Cory Spaulding and Leslie Yeisley request that the Siting Council reject Petition 1566 for failing to contain the minimum required information as required RSCA Section 16-50j-59 - Information Required.

RSCA Section 16-50j-59 - Information Required.

The required information listed in Section 16-50j-59 applies to petition 1566.

Existing Conditions Plan
PROJECT TITLE: <i>Owunneguhset Mountain</i> 716 Beaumont Hwy. Lebanon, Ct.
PREPARED FOR: <i>Cory Spaulding</i>

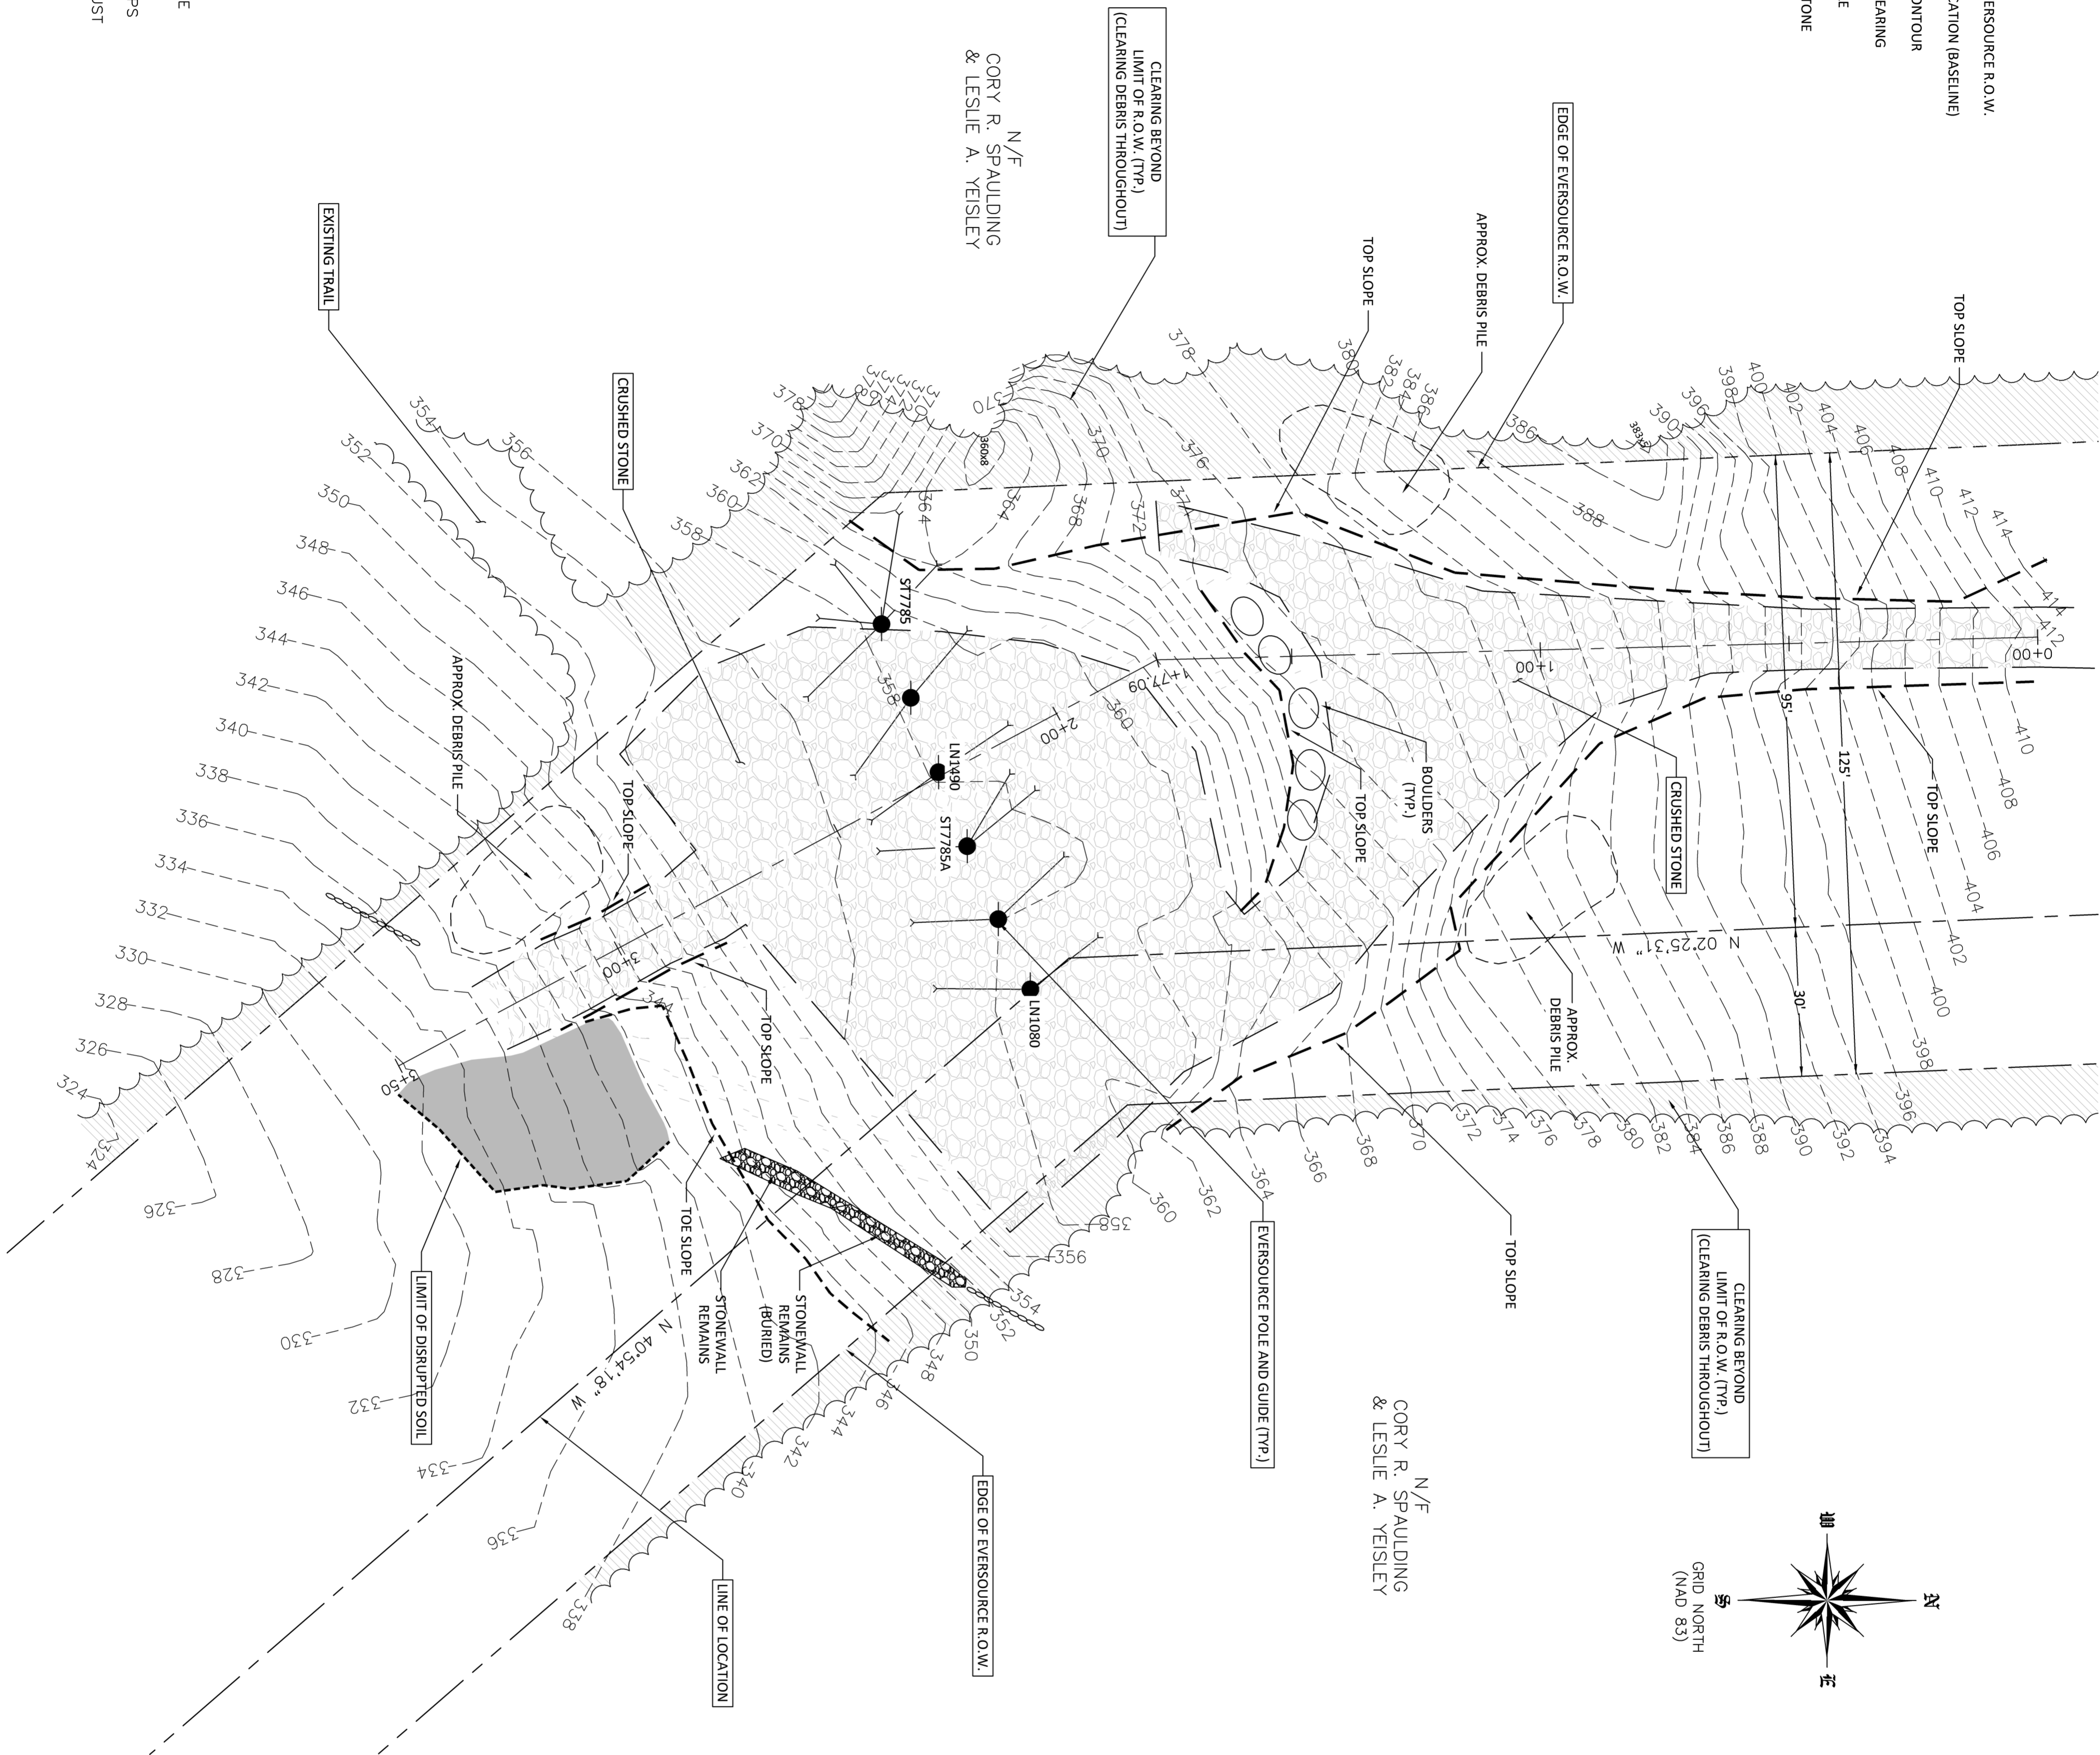
The elevation drawings and site maps submitted in the petition for site 7785 do not detail the existing conditions as detailed in the survey map provided in Exhibit 10. The discrepancies in this one site are so egregious that the submitted maps cannot be relied upon to accurately represent anything which is generally what the map note states. Eversource failed to disclose in the petition that site 7785 is classified by Eversource as a highly erodible area. A highly erodible soil area site condition requires accurate terrain and elevation maps and are critical to determining the appropriate mitigation for

Existing Conditions Plan

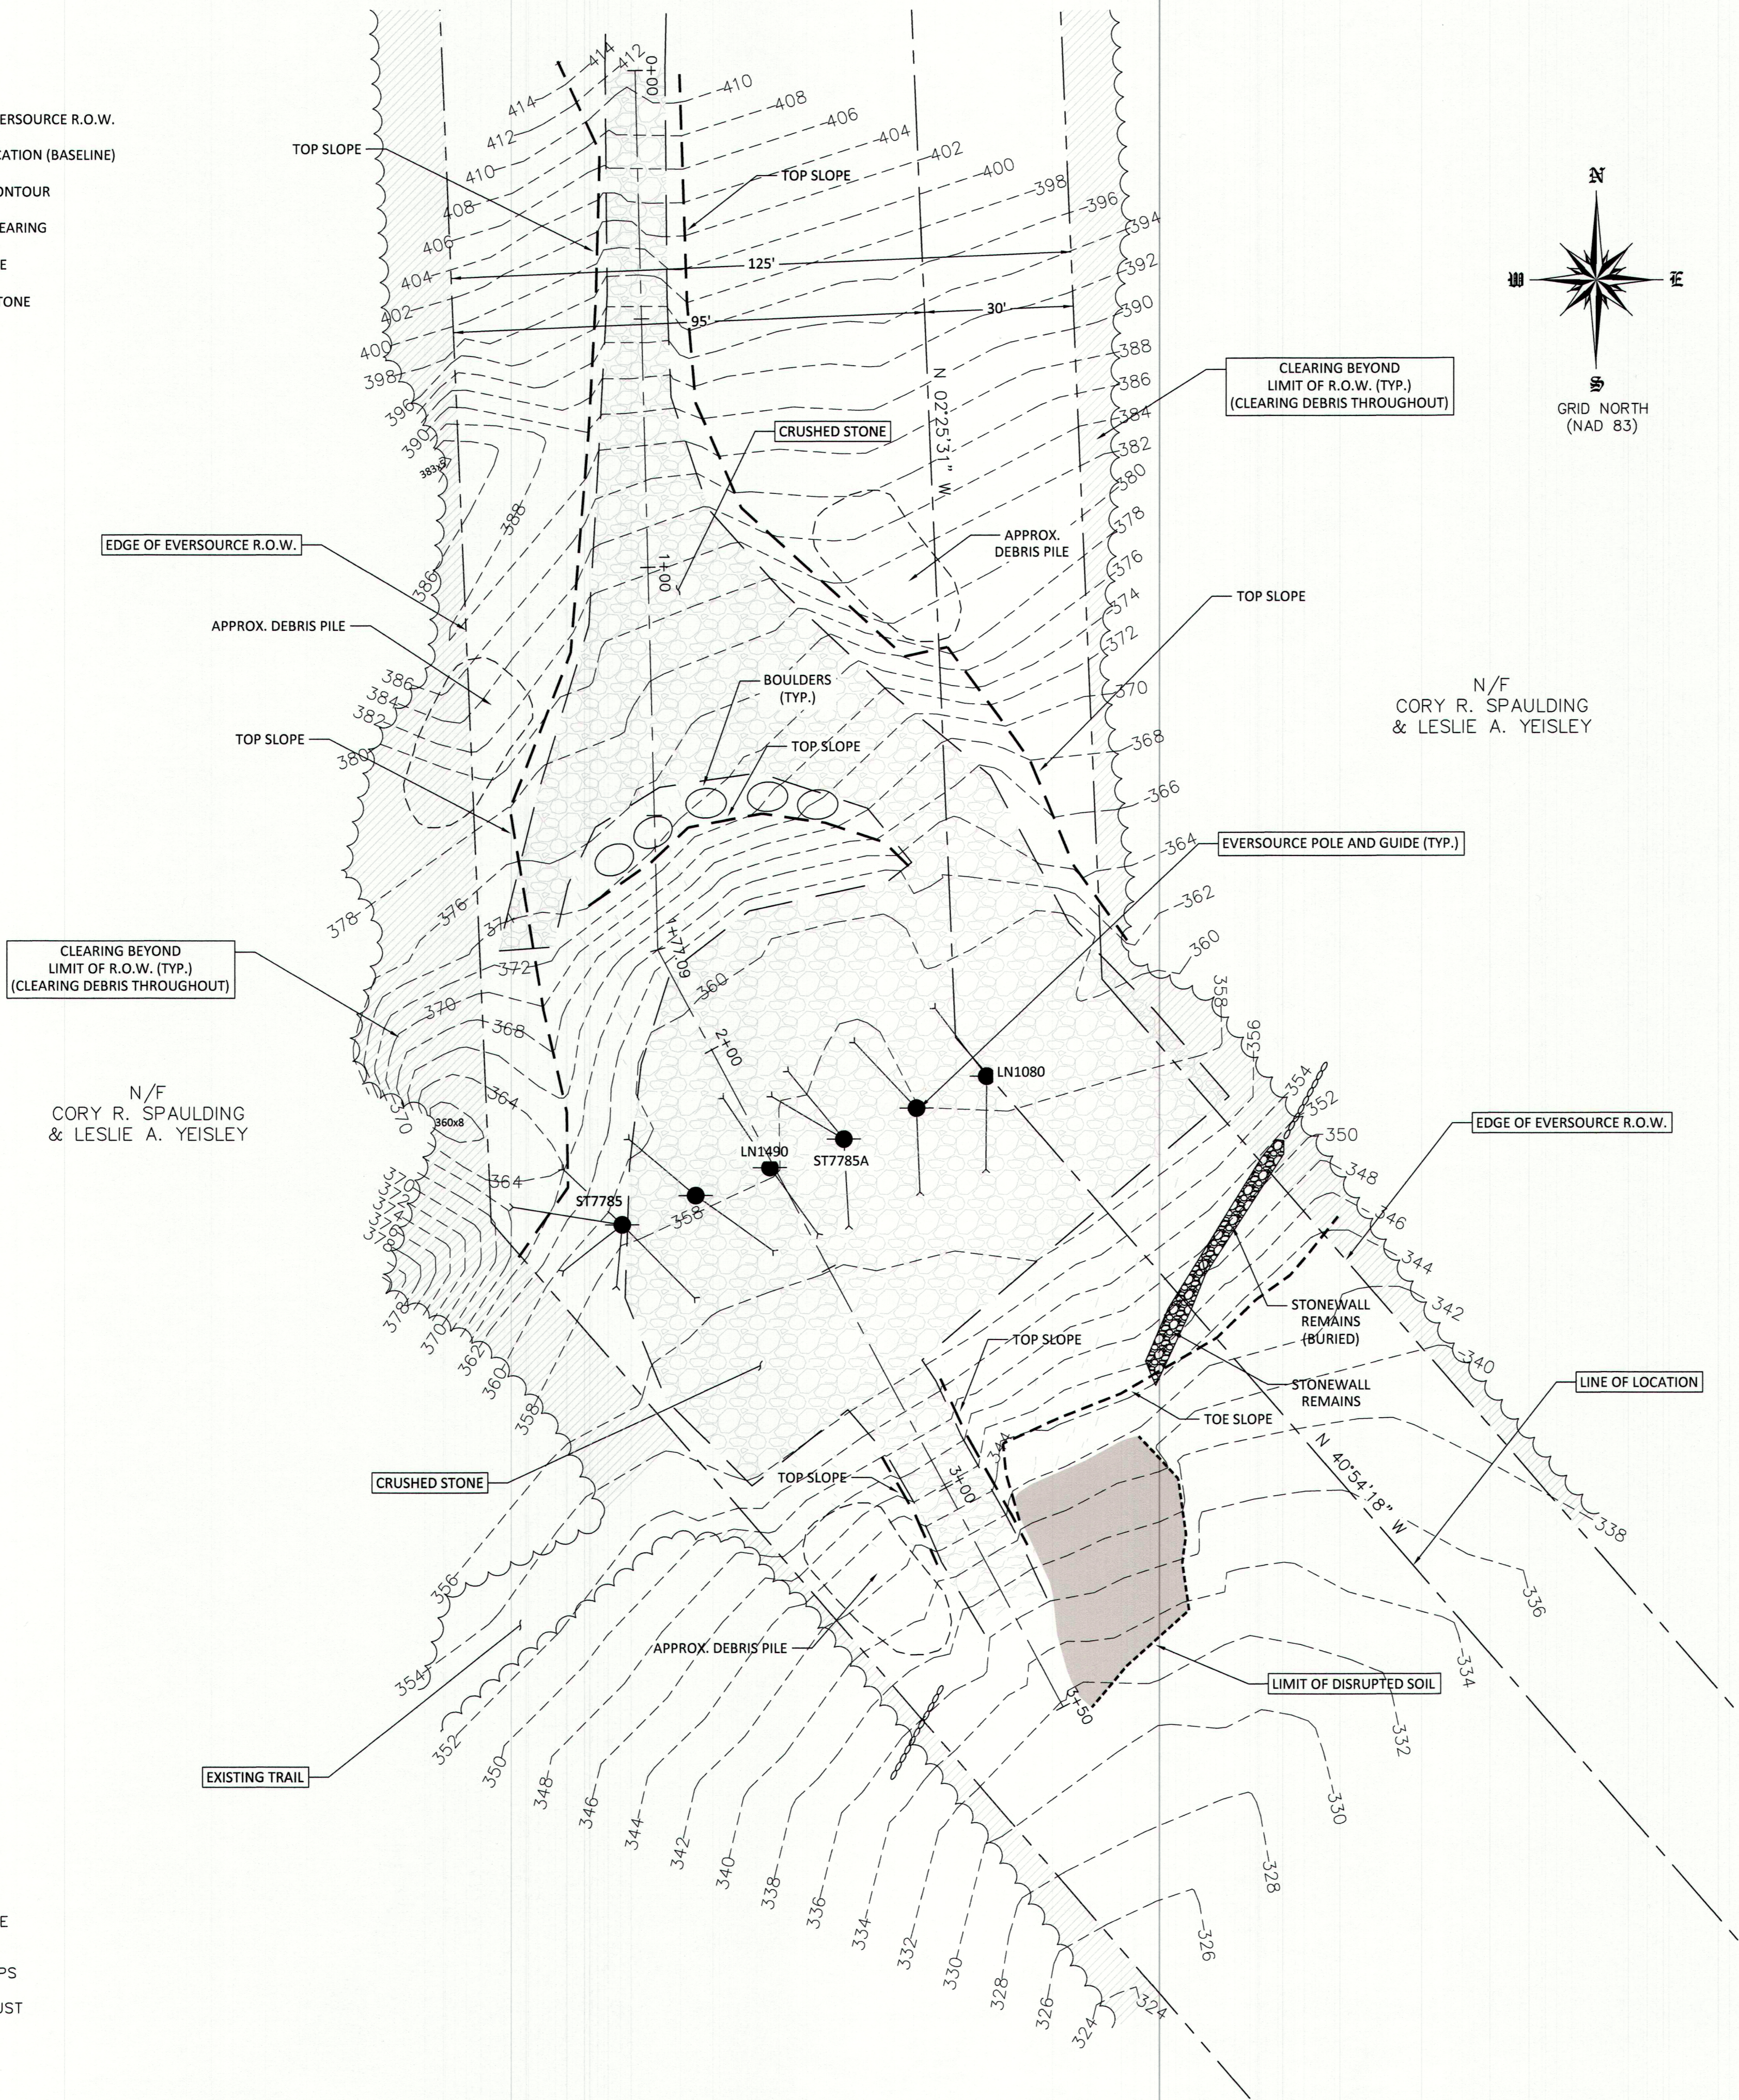
The 100ft x 140ft pad at site 7785 created a manmade terraced escarpment on the steep hillside where none previously existed. This, and other identified issues, are detailed in photographs below labeled "filled area site 7785" and Exhibit 7, a plan entitled "Existing Conditions Plan", drawing 1 of 3 dated 4/15/22 (22-037_Sheet_1_SCAN_5-11-22) which shows the extent of the disturbed soils at site 7785.
